TECHNICAL ADVISORY COMMITTEE REPORT

FILE NUMBER: 24-DP-24

SUBJECT: Preliminary Site Plan review for an approximately 2,490 SF Warehouse Building

WAREHOUSE METAL BUILDING
 6013 RODMAN STREET
 HOLLYWOOD, FL 33023

DRAWN: **D.J.A.**
 CHECKED: **D.J.A.**
 DATE: **JULY, 2022**
 SCALE: **AS NOTED**
 JOB. NO.: **22-005**
SP-1
 OF SHEETS

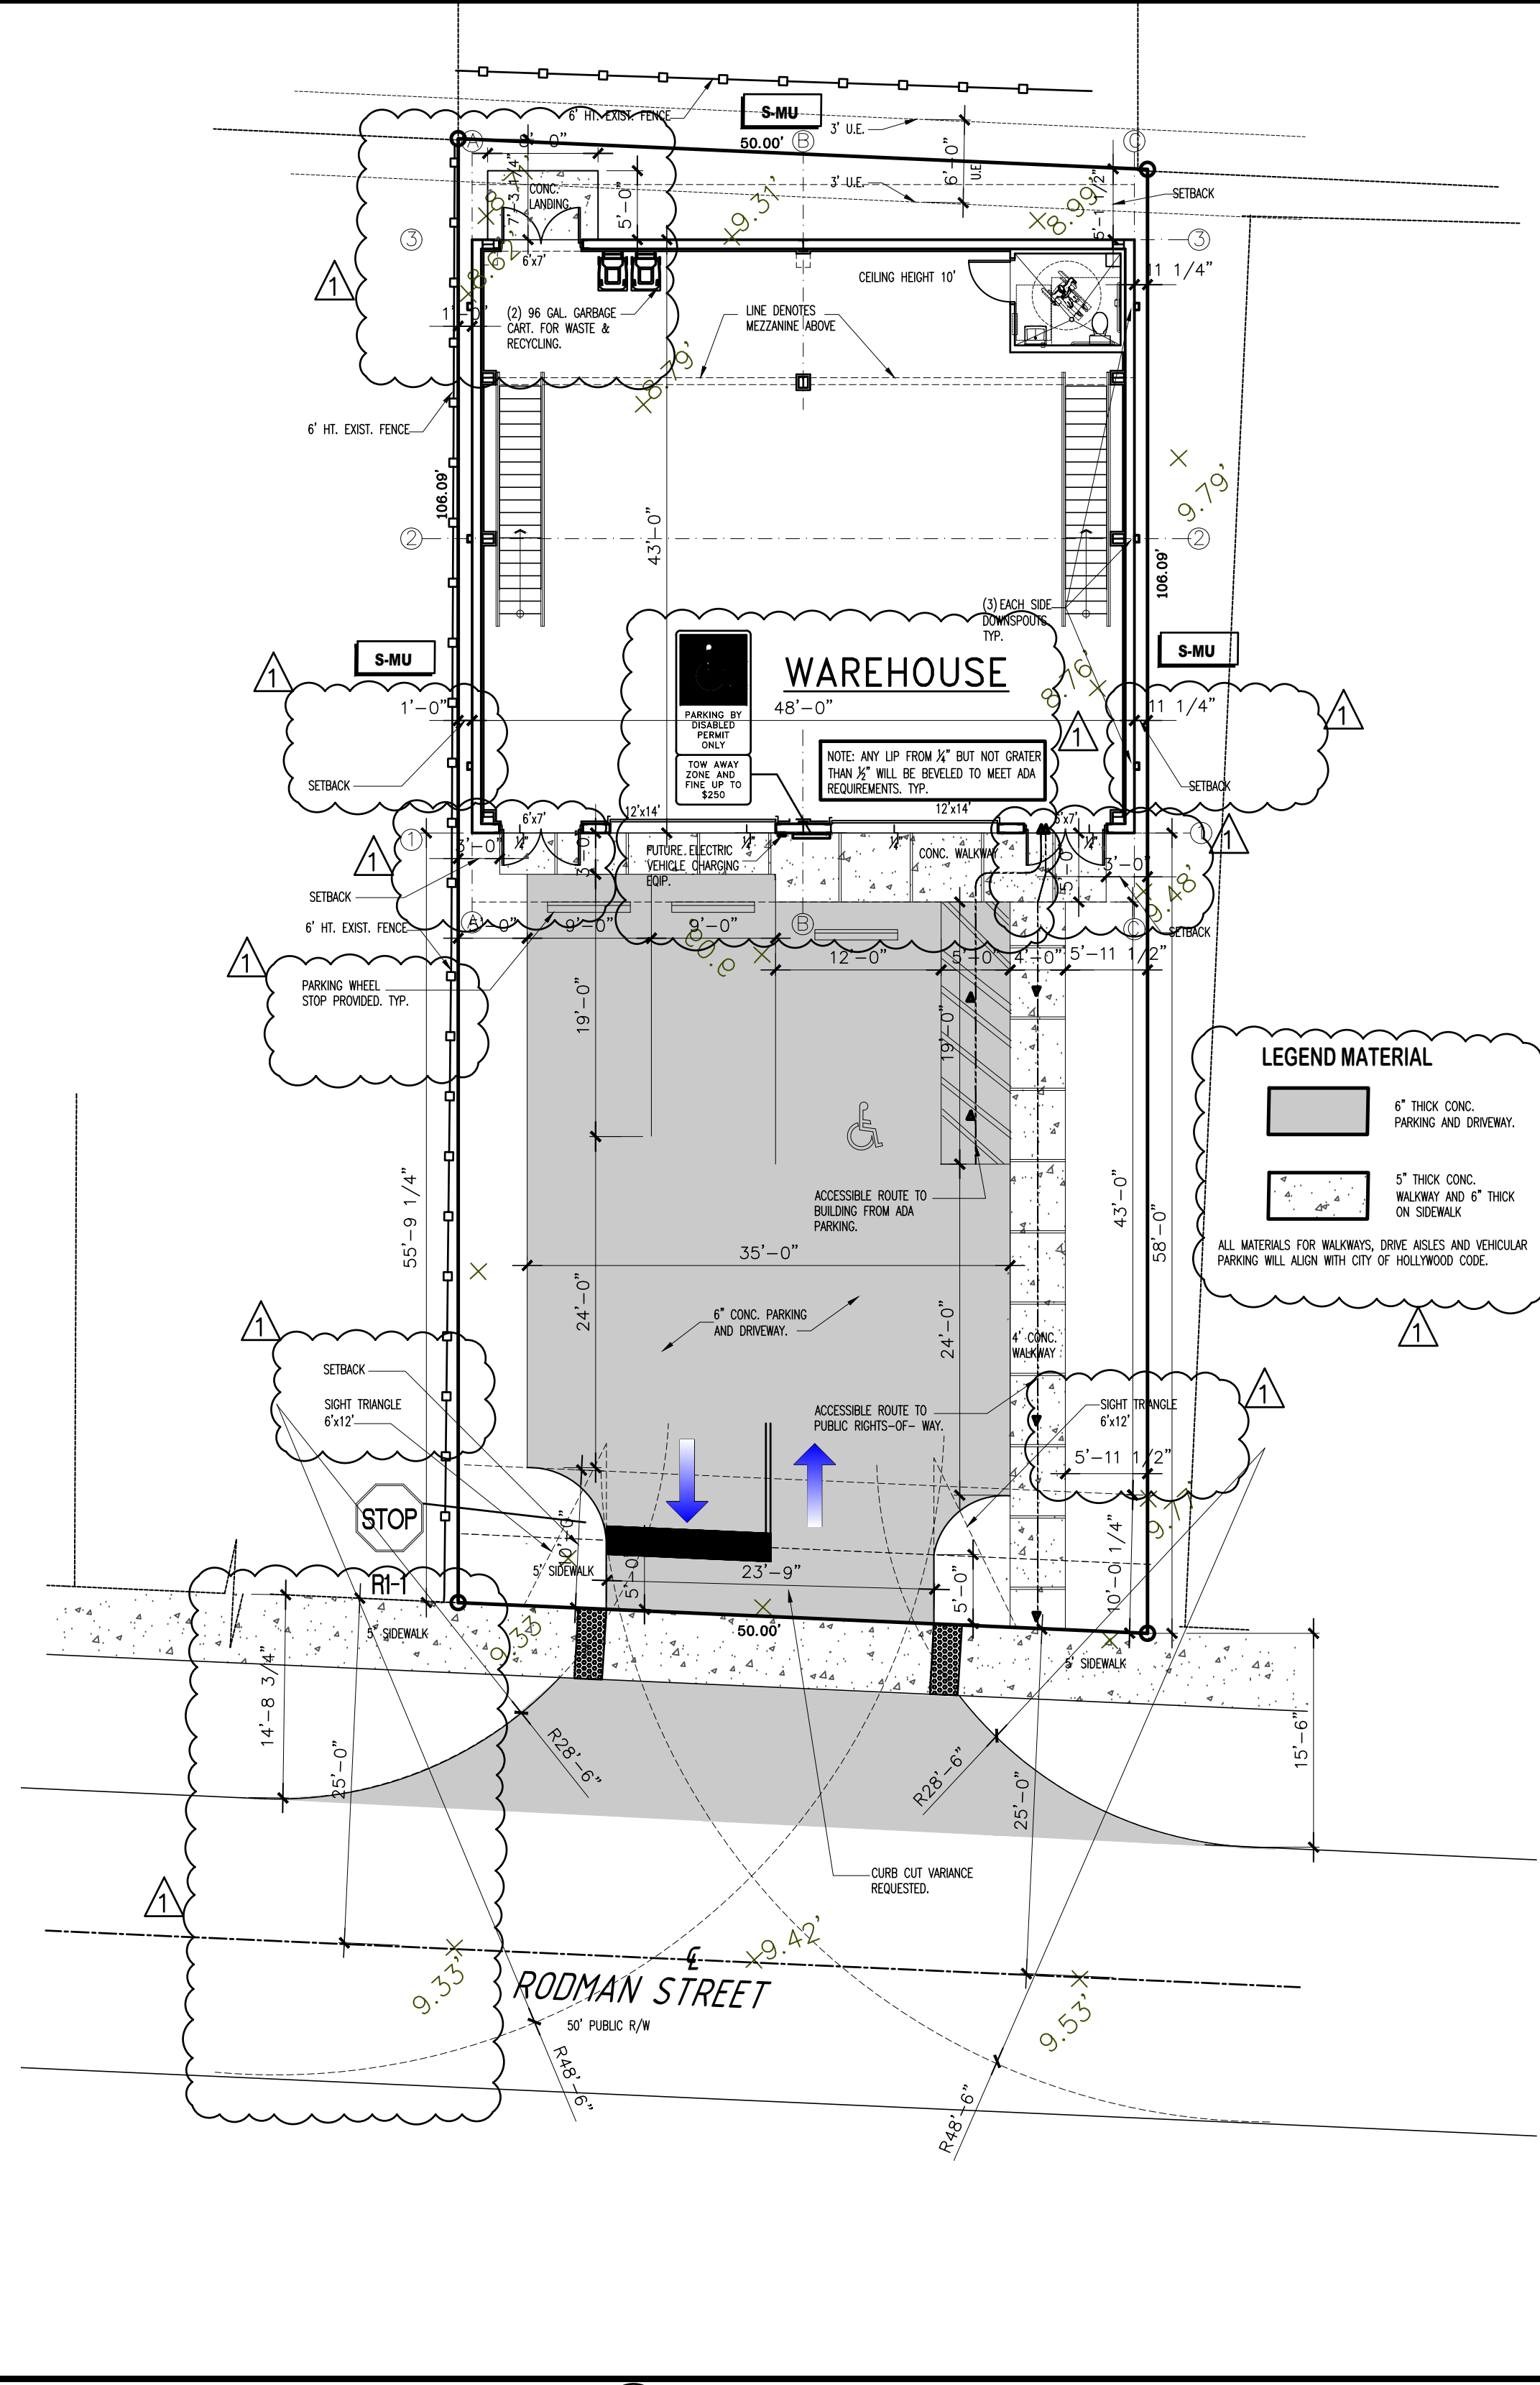
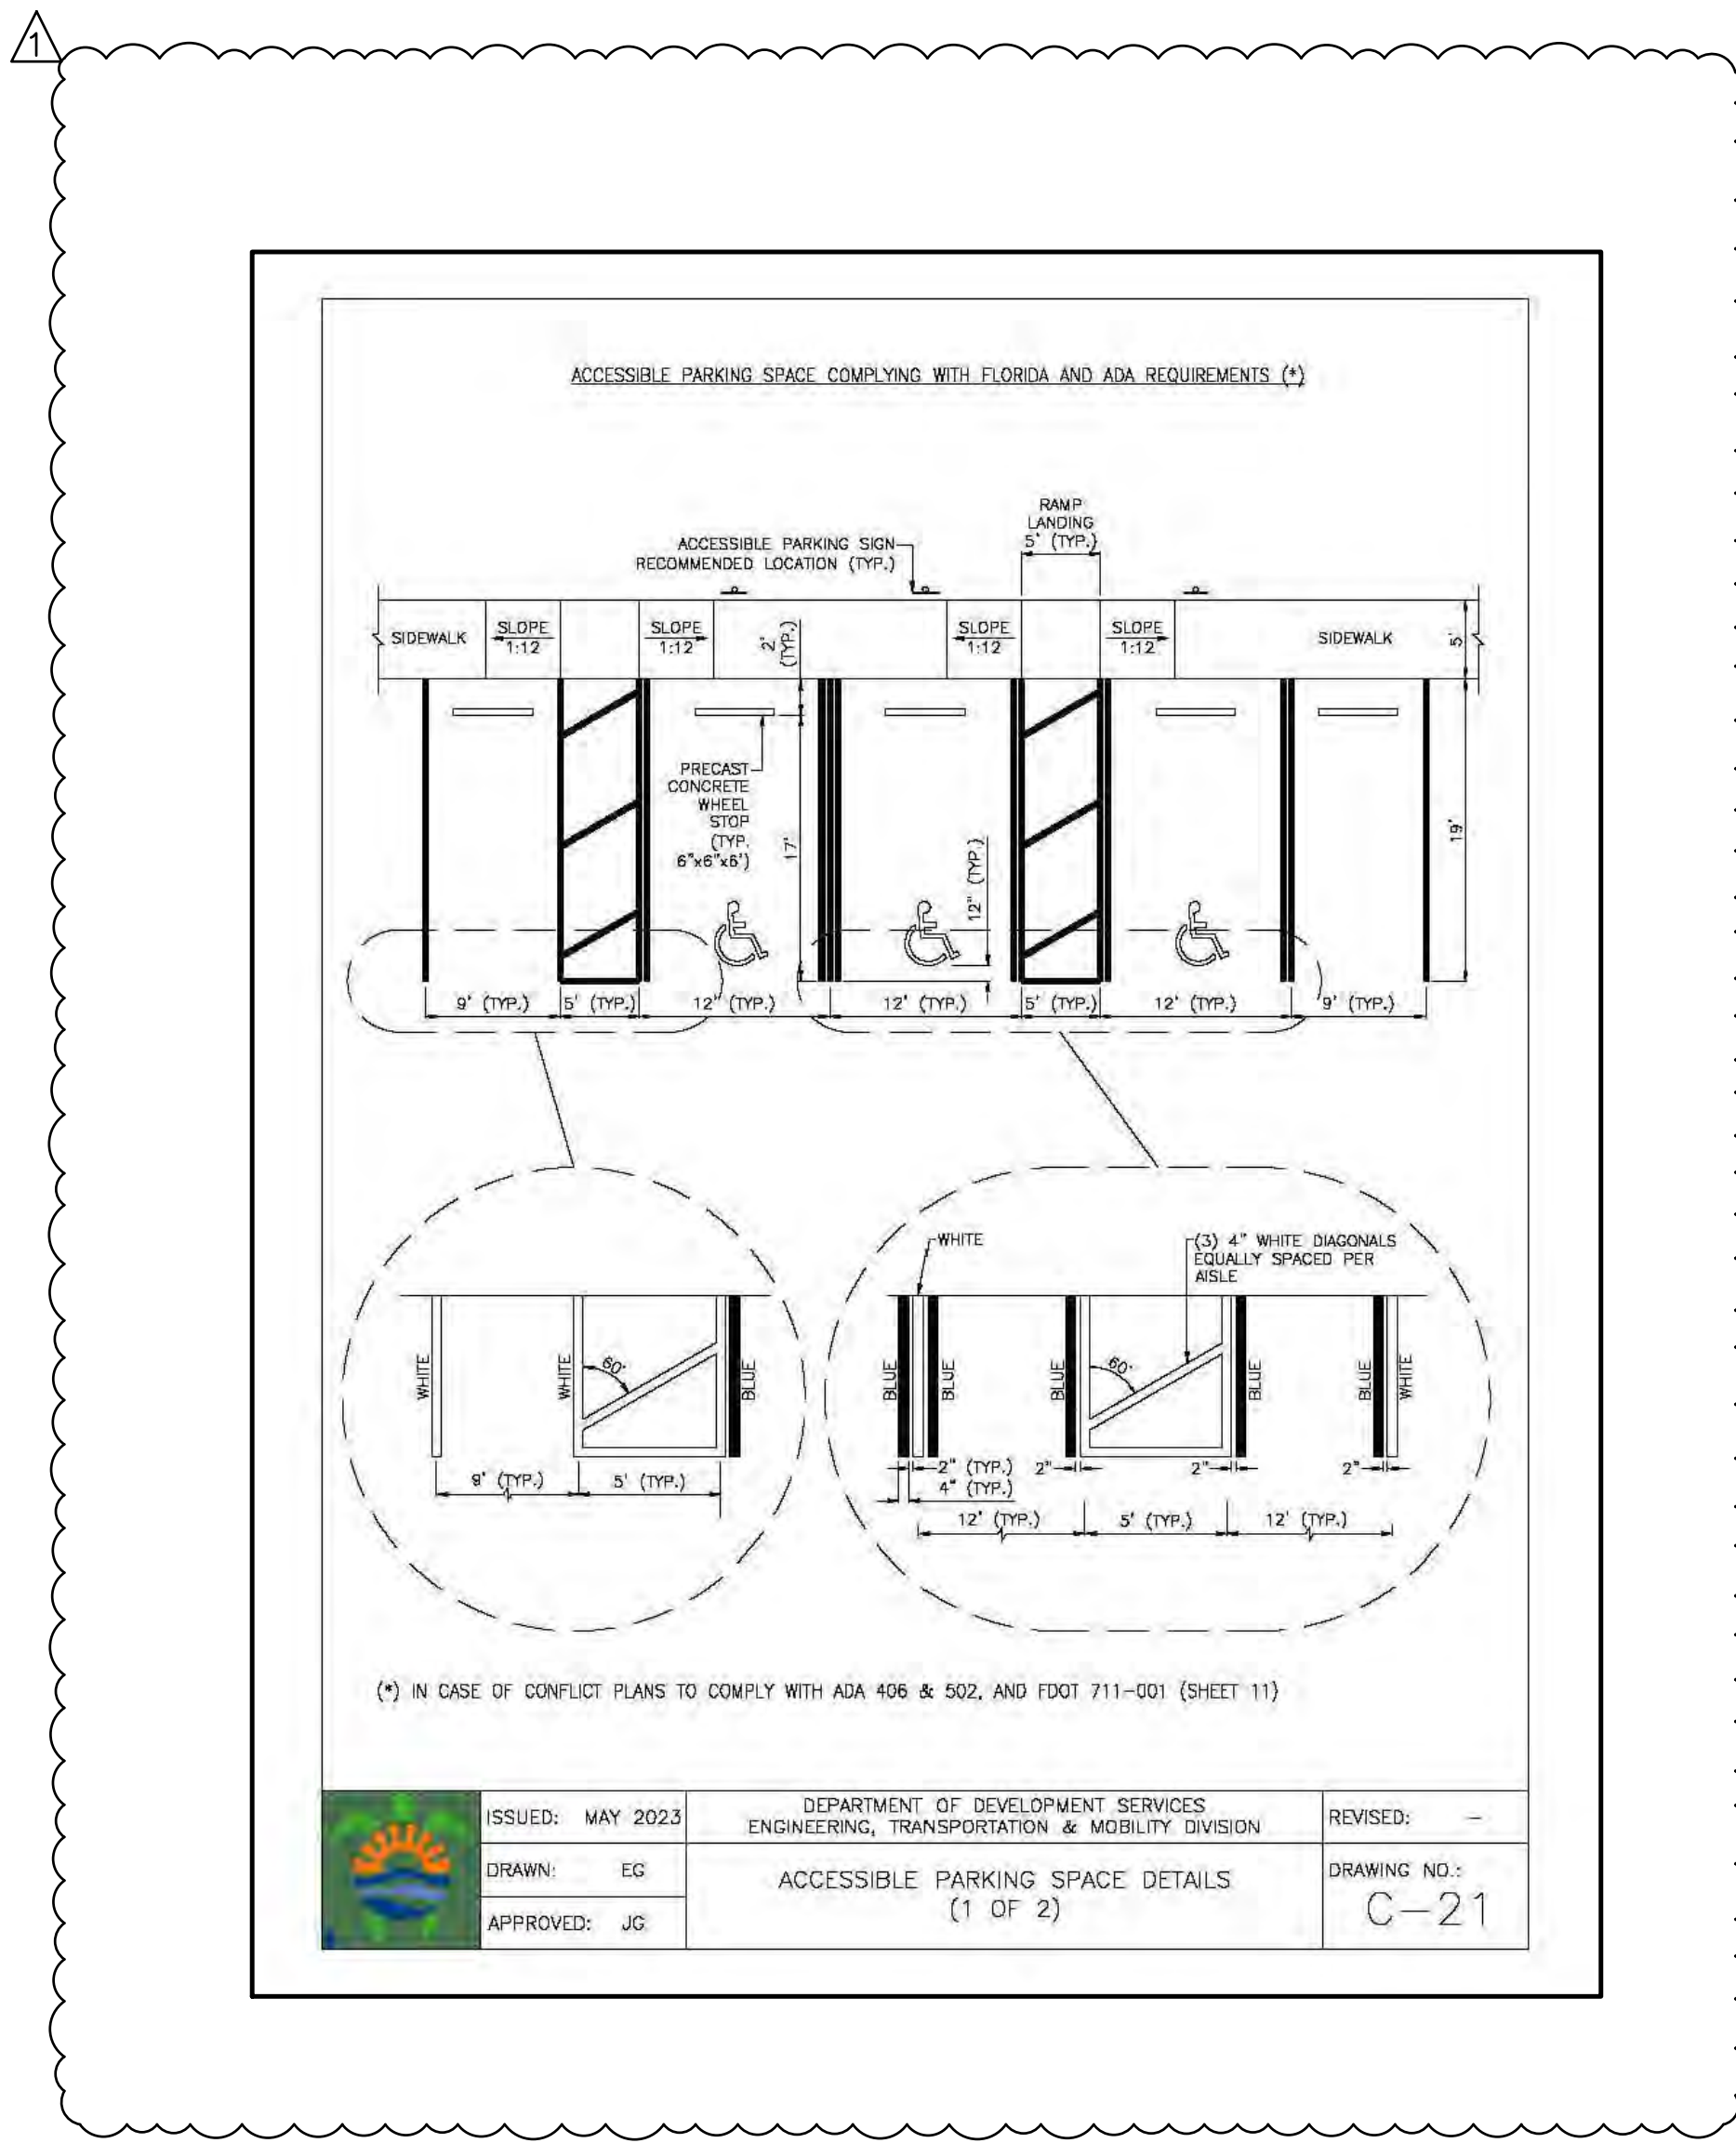
- a. Walkway shall be setback a minimum of 3' from the property line. **PLEASE SEE REVISED SP-1**
- b. Driveway exceeds the 30% maximum curb cut for a 50' wide lot. Shall be a maximum of 18'. **WE ARE APPLYING FOR A VARIANCE.**
- c. Drive isle shall be a minimum of 18' in length before widening. **PLEASE SEE REVISED SP-1**
- d. No walkway or hardscaped surface shown from exterior door. Indicate the surface. **PLEASE SEE REVISED SP-1**
- e. Survey shows the U.E. is 6'. Site plan states 3'. Ensure the site plan corresponds to the survey. **PLEASE SEE REVISED SP-1**

- 1. Indicate on the site plan where the infrastructure necessary for future installation of electric vehicle-charging equipment will be located. (See 151.154, Ordinance O-2016-02). **PLEASE SEE REVISED SP-1**
- 2. Refer to Building for any required green building practices. **UNDERSTOOD**

- c. All features of City streets and alleys within full City right-of-way on both sides from property line to adjacent property lines.
PLEASE SEE THE REVISED SITE PLAN SP-1.

7. Please call out the setbacks provided on the site plan stating the word setback and providing the dimension. **PLEASE SEE REVISED SITE PLAN SP-1**
8. Please show and label the dumpster location and identify the type of door to be used for the dumpster enclosure. Call out in plans. **N/A WE ARE USING 96 GALLON WEELED TRUSH CART**

16. Be sure building square footage is consistent throughout, discrepancies exist between Sheet SP-1 and Sheet A-1.0. **PLEASE SEE REVISED SP-1 AND A-1.0**

17. Indicate on plans if curbing will be provided for the parking area. **NO CURBING IN PROPOSED ON PARKING LOT**
18. Please show and label on signage on SP-1. **PLEASE SEE REVISED SITE PLAN SP-1**

24. Applicant is showing a sidewalk connection utilizing the parking lot to provide access from the entrance of the building to the sidewalk in the ROW. Consider providing a sidewalk adjacent to the parking lot to avoid pedestrian and vehicular traffic crossing over one another. **PLEASE SEE THE REVISED SITE PLAN SP-1.**
